**Steven M. Clouse WRC Electrical System Improvements Phase II**  
**Solicitation Number: CO-00276**  
**Job No.: 16-6501**

**ADDENDUM 3**  
**March 16, 2021**

**SAN ANTONIO WATER SYSTEM**  
STEVEN M. CLOUSE WRC  
ELECTRICAL SYSTEM IMPROVEMENTS PHASE II  
INSTRUMENTATION  
**FIRST STAGE AERATION TANKS**  
SCADA/IT ROOM  
RACK DETAIL

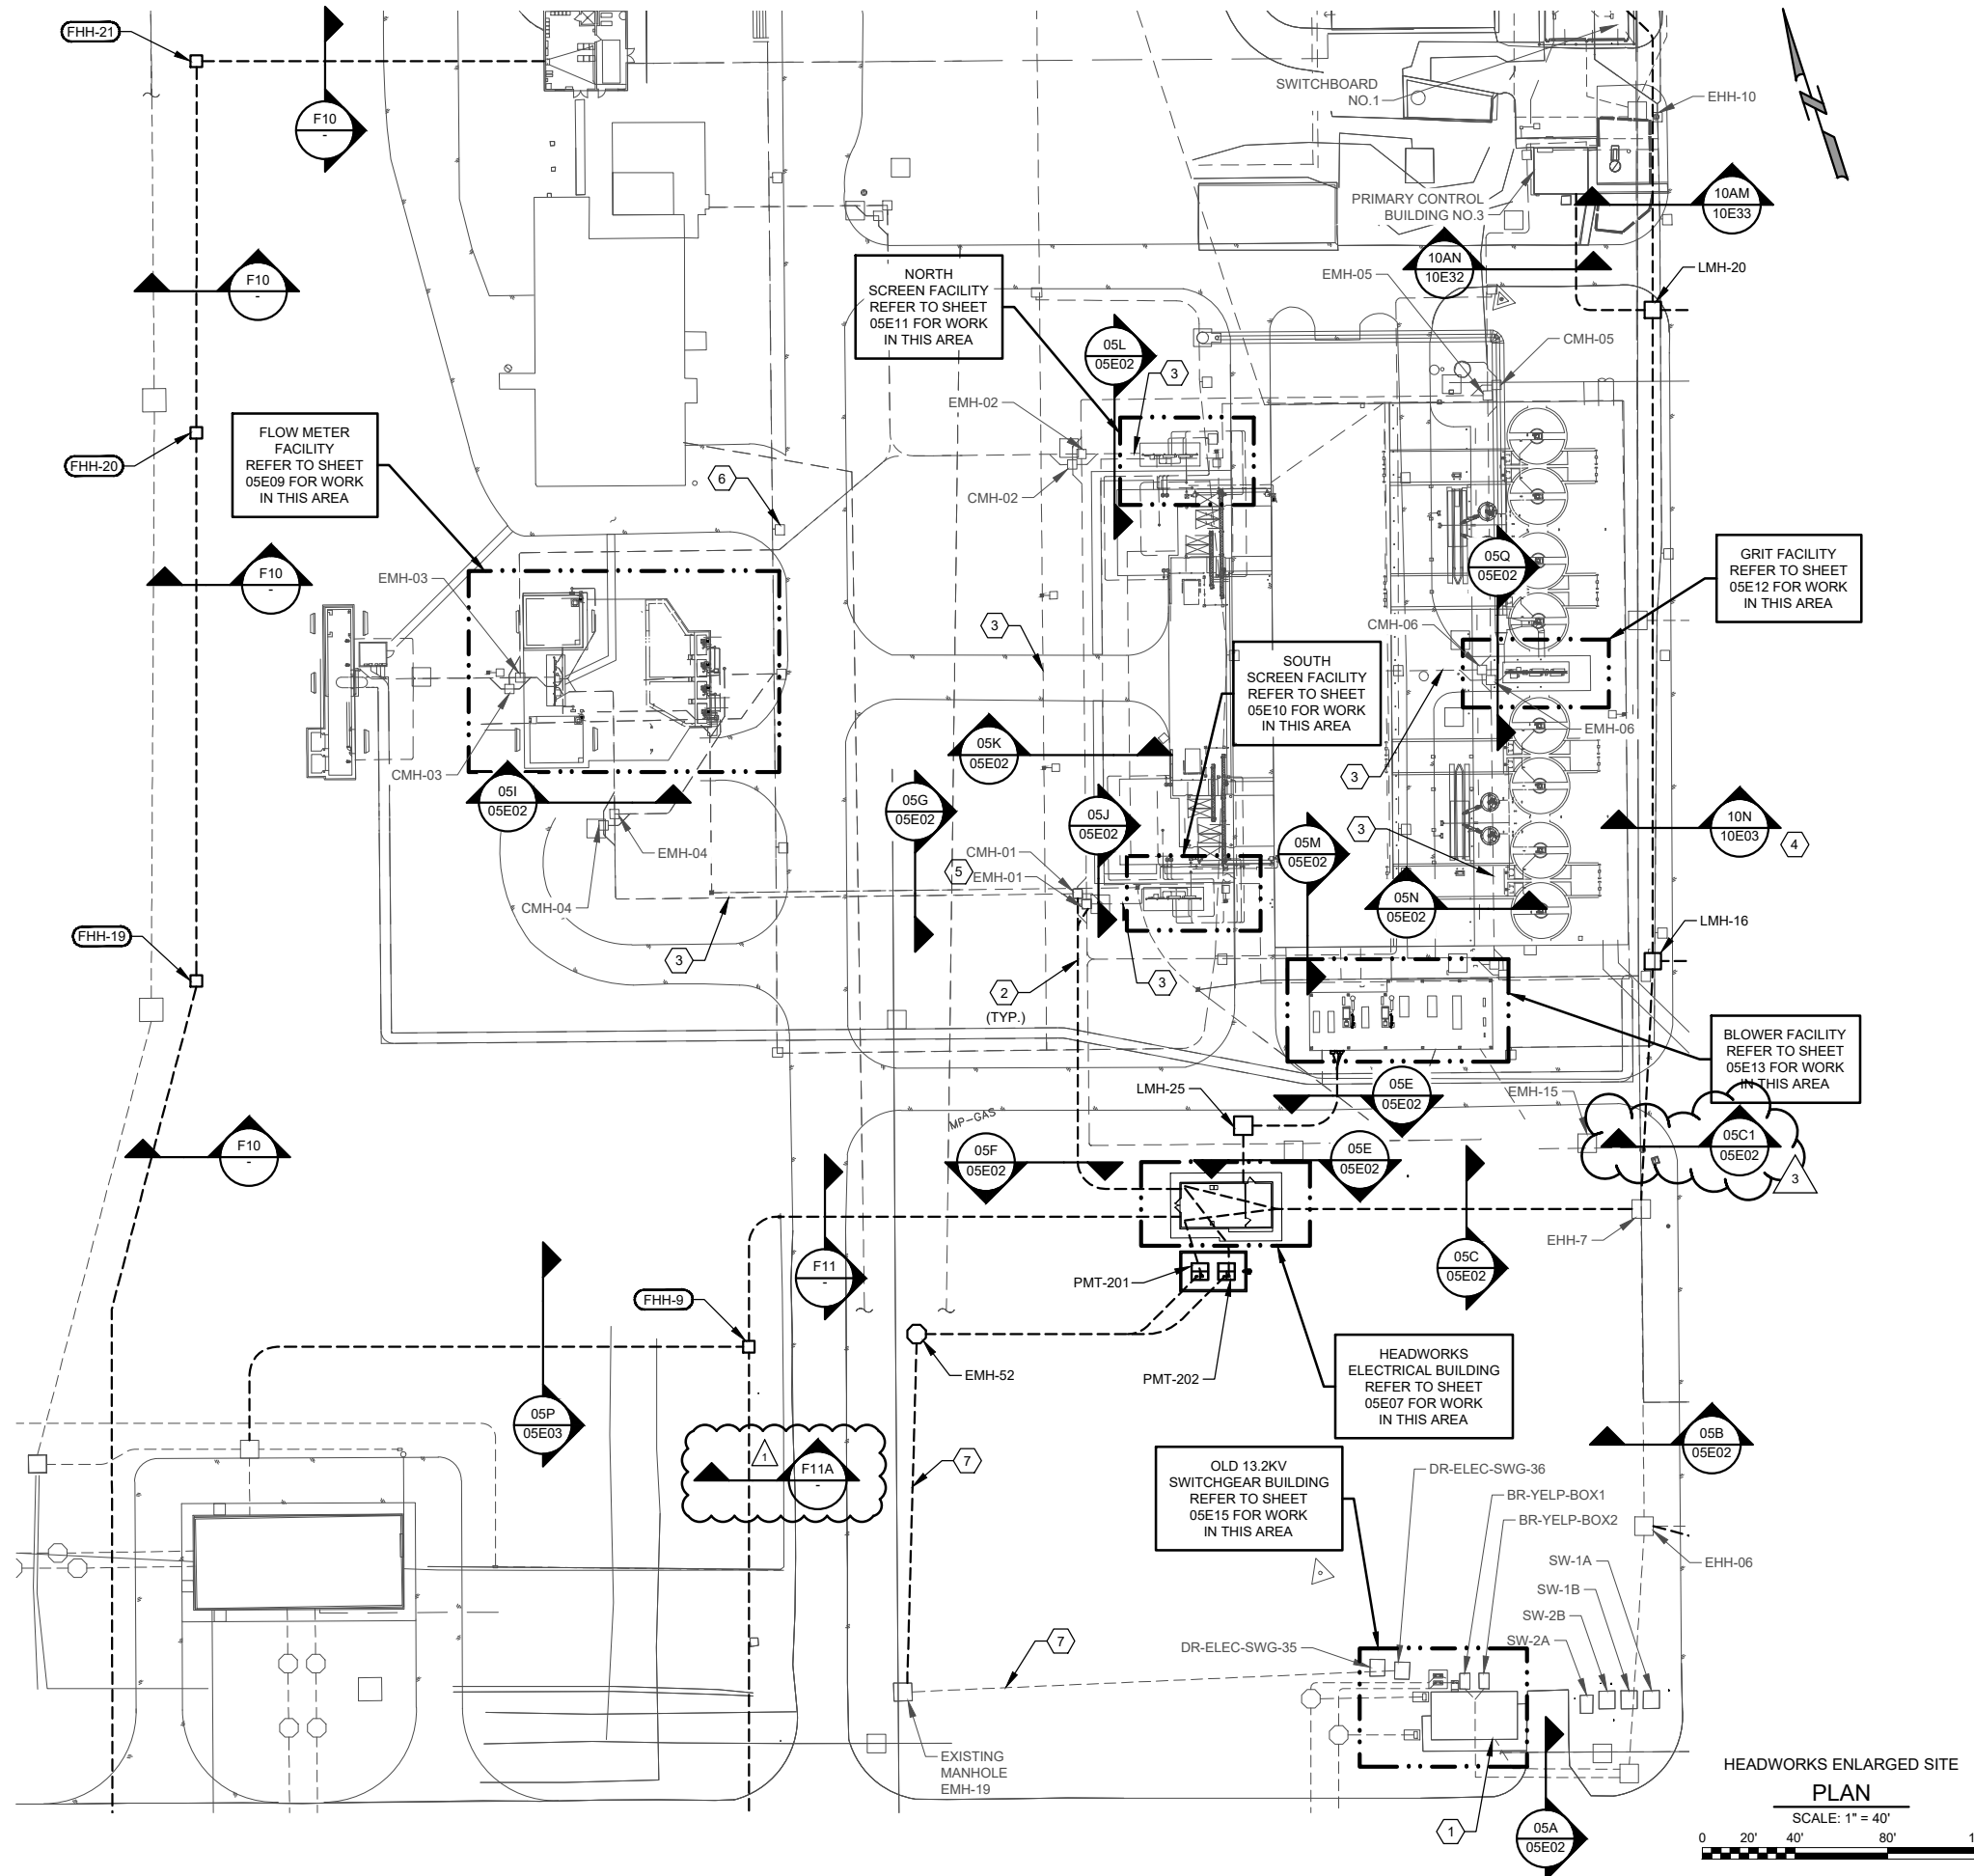
29. Drawing 00N05 indicates two SCADA Firewalls located in the SCADA Network Switch Rack. However, there is no specification in reference to these firewalls. Please provided specification for the SCADA Firewalls.

*Response: Firewalls will be provided by SAWS. Refer to "Changes to the Plans," item 1.i.*

3/10/2021 2:37 PM Z:\1951\_SAWs Dos Rios WRC Electrical System Improvements - Phase II\5 Drawings\Dos Rios Phase II\Electrical\Working\1951\_30E10.dwg, Mario Lipari

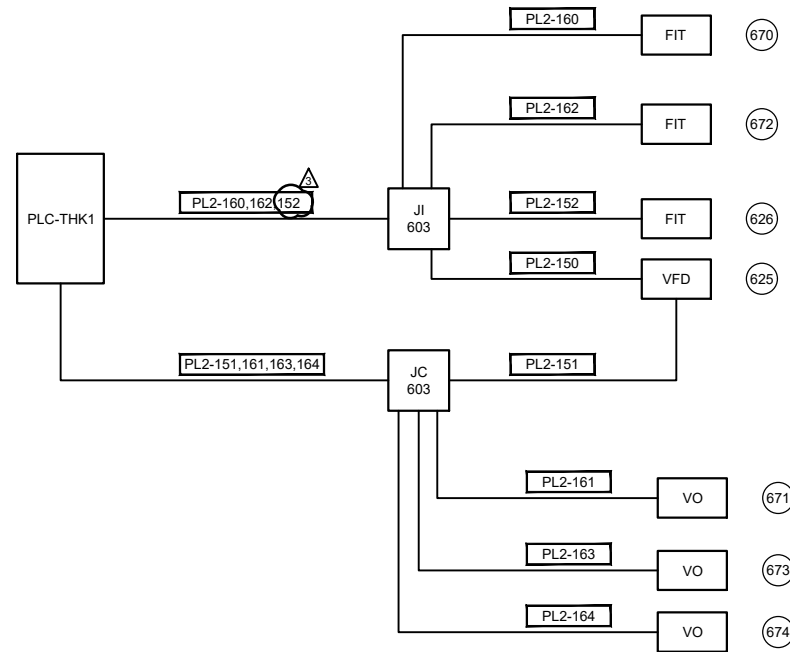
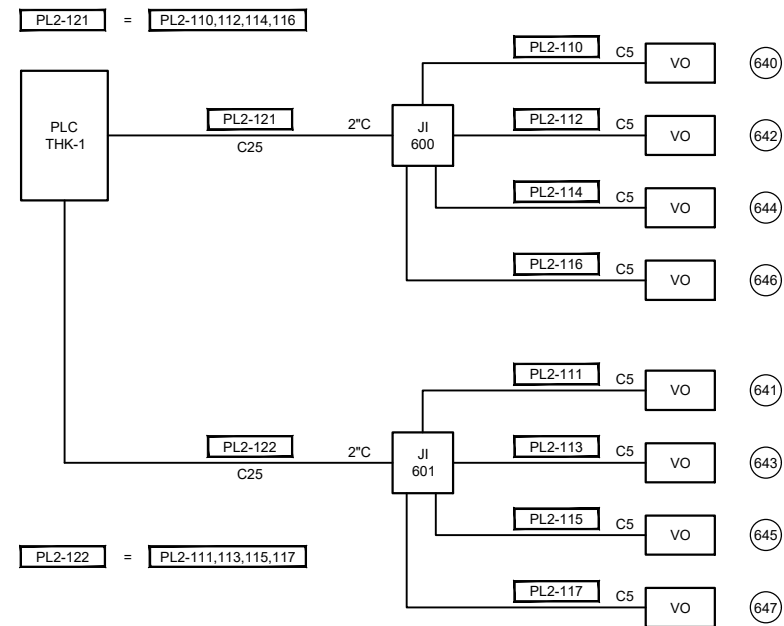
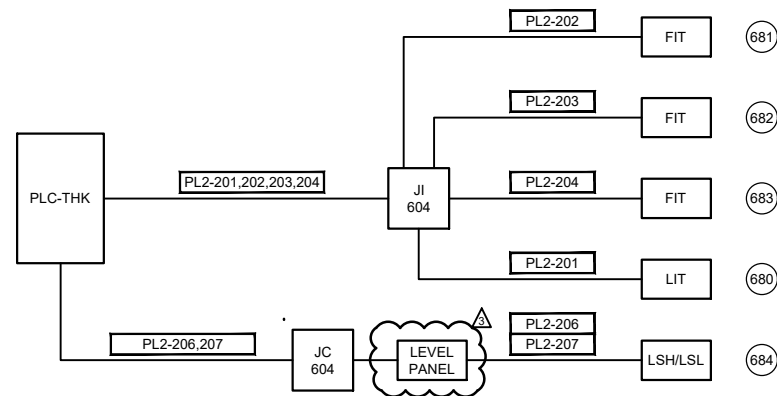
6. Sheet 30E10 equipment tag 626 Sludge Bypass Flow shows circuit number PL2-152 from JI-602 and as PL2-142 from JI-603. PL2-142 is not shown on 30E07. Please clarify.

7. Circuit PL2-130 on sheet 30E10 is to be combination of PL2-142,125,126,127,128,129. But ductbank section A on 30E03 shows PL2-129 as a separate circuit from PL2-130. Please clarify.

8. Sheet 30E10 General Note # 3 states all wires and conduits shown on drawing is to be installed. At the Sludge Blending Tank-1 level, riser diagram calls for LSH/LSL to be wired directly. However, P&ID 30N04 indicates that there is a Level Control Panel. Similar situations exist for Blend Tank 2. Are we to bypass the level control panel and wire the instruments directly? Please clarify.

*Response: Refer to "Changes to the Plans," item 1.r.*

*Response: The section on sheet 30E03 is correct, PL2-129 should be routed in a separate conduit. Refer to "Changes to the Plans," item 1.r.*

*Response: The wires shall be wired from the level control panel. Refer to "Changes to the Plans," item 1.r.*

SHEET NO.  
**30E15**  
440 OF 500

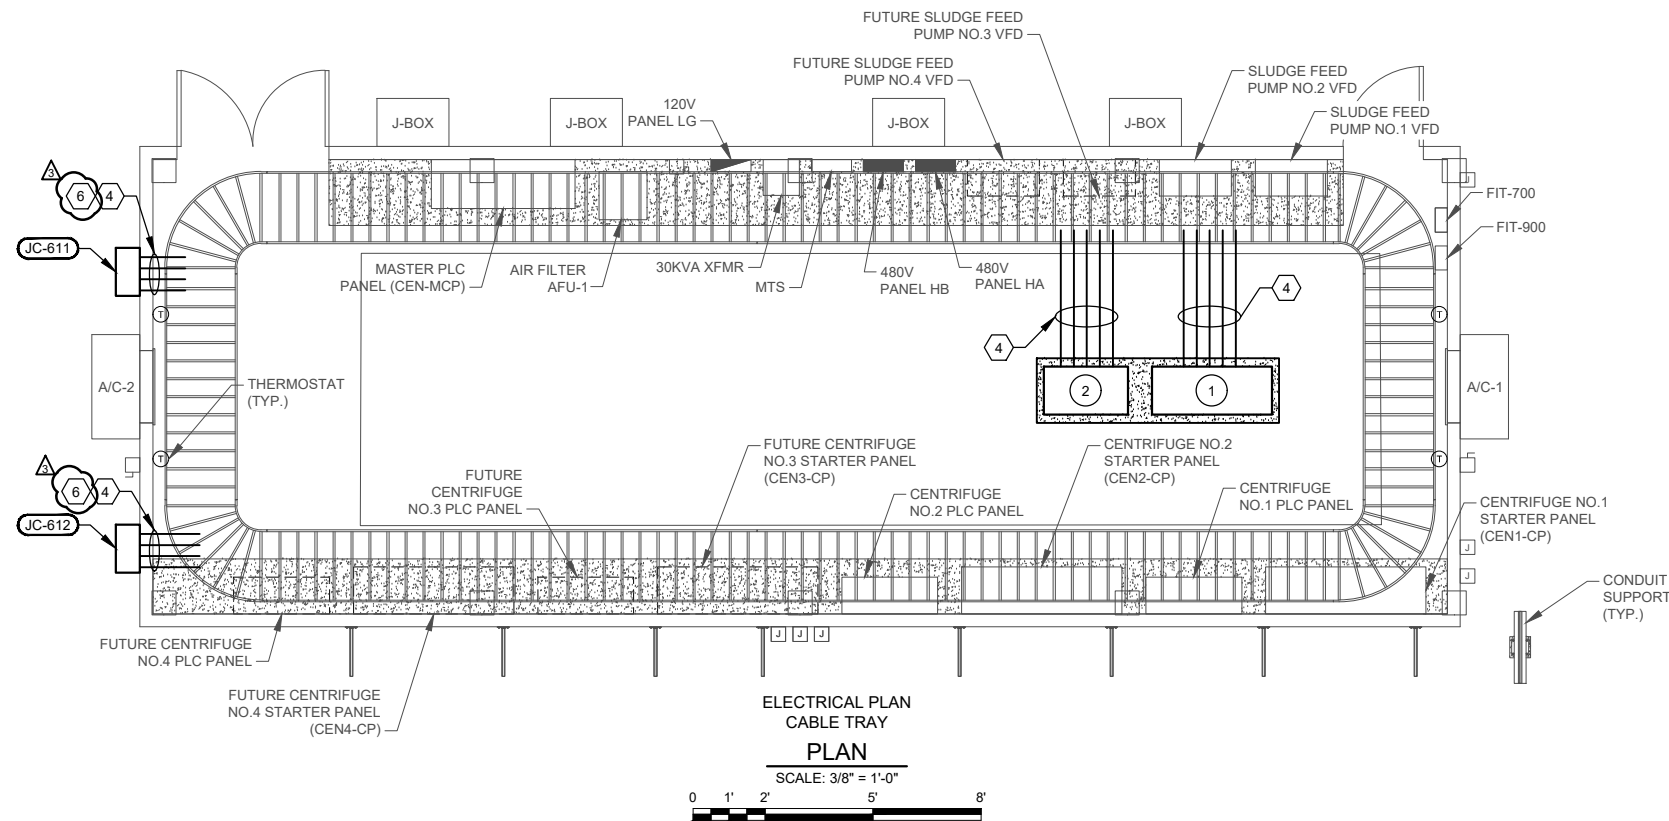
19. Sheet 30E15 please provide more info regarding PL-EMC between Concentrator and existing pullbox to existing ductbank. Sheet reference table refers to 30E11, however, there is no information regarding PL-EMC on that sheet. Sheet 30E12 does show a circuit between Concentrator and Controller 8/58, however no information is provided regarding cable type or location. Please provide circuit information and routing.

20. Sheet 30E15, circuit from Polymer Bulk Tanks to junction box in the electrical building are shown as PL1-240, 243, 241, 244 instead of PL-2225, 226. Please confirm.

*Response: Delete conduit tag PL-EMC. Refer to "Changes to the Plans," item 1.s.*

*Response: Change conduit tags to PL-225 and PL-226. Refer to "Changes to the Plans," item 1.o.*

SHEET NO.  
**30E16**  
441 OF 500

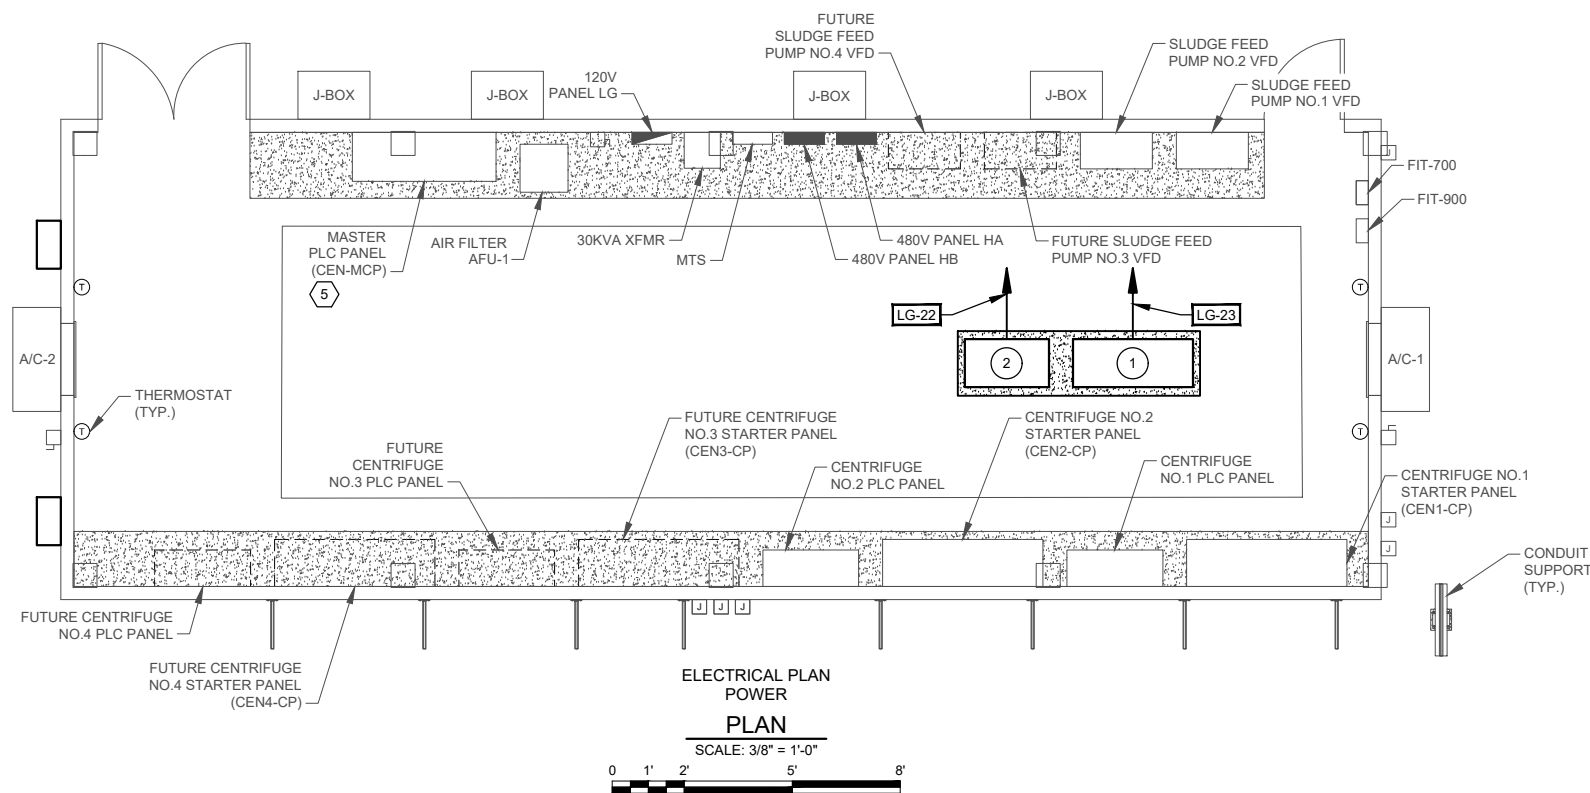
21. Sheet 30E16 PLC is tagged as PLC-THK1 instead of PLC-THK. Please confirm this should be PLC-THK.

22. Sheet 30E16, Keynote 4 indicates conduits from field to PLC and Network enclosure to be routed in tray. Please confirm the fiber optic cables are to be routed in existing cable tray as well.

*Response: Change label from PLC-THK1 to PLC-THK. Refer to "Changes to the Plans," item 1.t.*

*Response: Add note-6 to sheet 30E16. Refer to "Changes to the Plans," item 1.t.*

SHEET NO.  
**30E31**  
456 OF 500

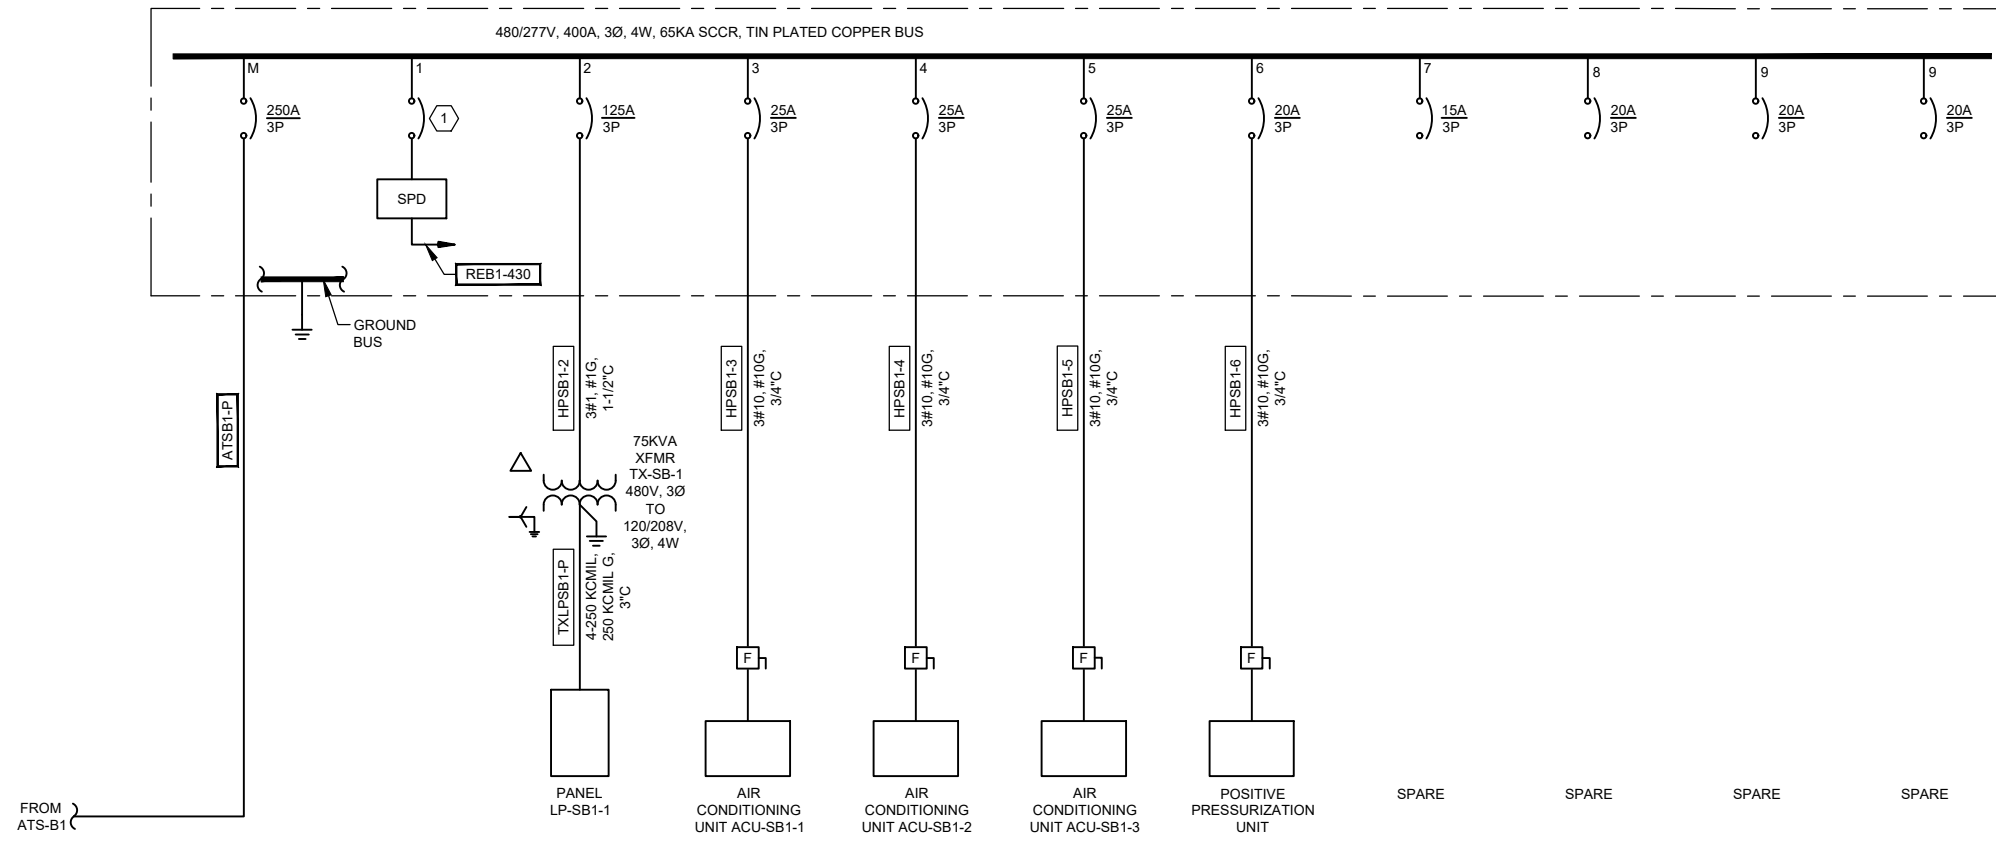
16. Sheet 30E05 existing ductbank section N, Keynote 1 refers to 30E31 for spare availability. Sheet 30E31 does not include ductbank section N. In addition, it seems the ductbank section N on 30E02 seems to be routed near the existing MCC-FF-1 Pullbox, enlarged drawing on 30E22 shows conduit to existing analog junction box located on the northwest corner of the pump station and ductbank conduits routed to the northwest corner. And sheet 30E22 shows PL-221(3-2 Pair #16) and PL-221(equivalent of 3-2 Pair & 3-6 Pair #16) along with PL1-P1 (3/C#12), please clarify these cable types as they are to be routed in 1" conduits in DB N in addition these needs to be routed in tray at the Centrifuge Electrical Room.

*Response: On sheet 30E31 section B is changed to section N. Install the wires as shown on the drawing in spare 2" conduit and via cable tray. Refer to "Changes to the Plans," items 1.o and 1.w.*

SHEET NO.  
**40E02**  
491 OF 500

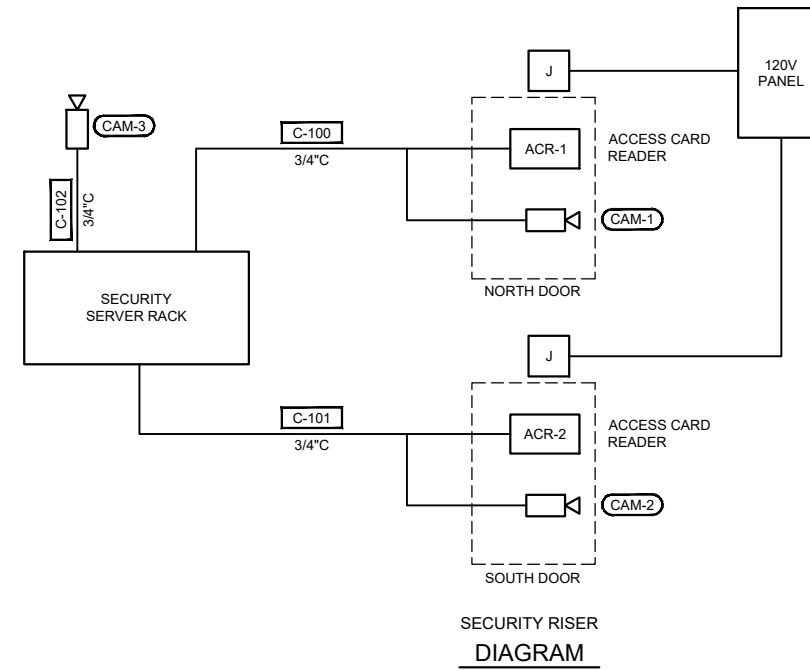
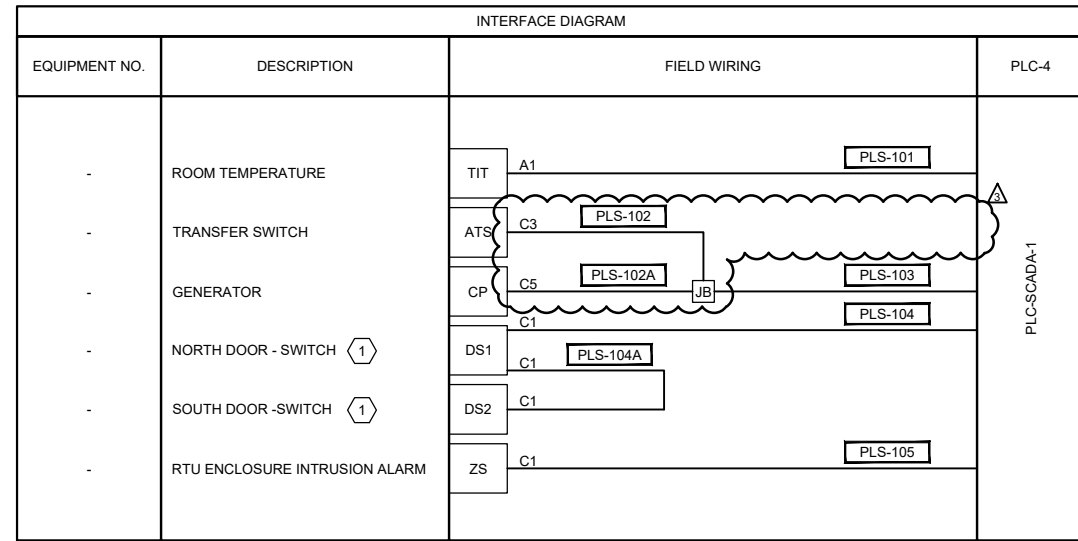
3. Sheet 40E02 circuits GENSB1-C, DLS-103, does not correlate with the Interface Diagram shown on 40E05, also please identify circuit between the junction box and Generator as needed.

*Response: Refer to “Changes to the Plans,” items 1.x and 1.y.*
